VKPC 95898

Technical Bulletin - March 2011

OE/SKF DESIGN EVOLUTION
VKPC 95872 is replaced by VKPC 95898

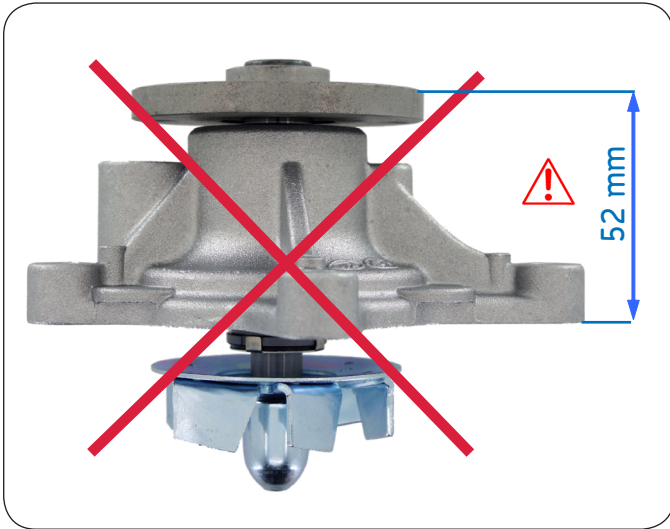
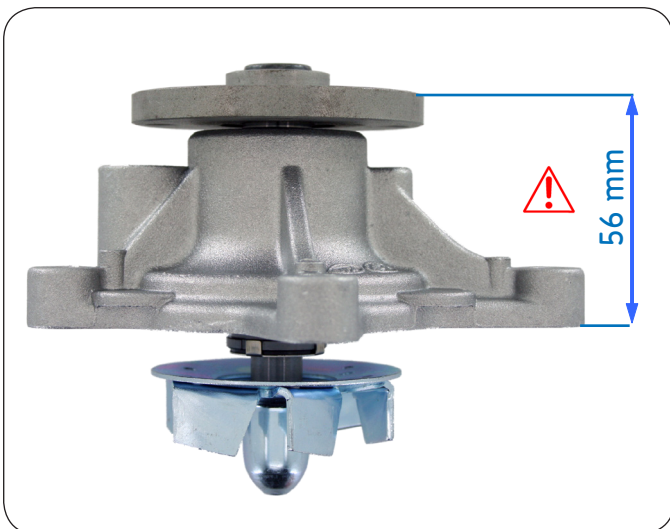
HYUNDAI OE has changed the design of water pump on the early car models.

HYUNDAI stopped the supply of the old waterpump, equivalent to VKPC 95872 which is used in applications from year 2000-2006. HYUNDAI recommends replacing the old waterpump to the new evolved design + fitting a new pulley, ensuring the proper belt alignment and fitting is maintained.

New pulley required
to ensure correct belt
alignment

To follow car makers' specifications, SKF offers the equivalent waterpump together with the pulley to cover for the old application as per Hyundai instructions.
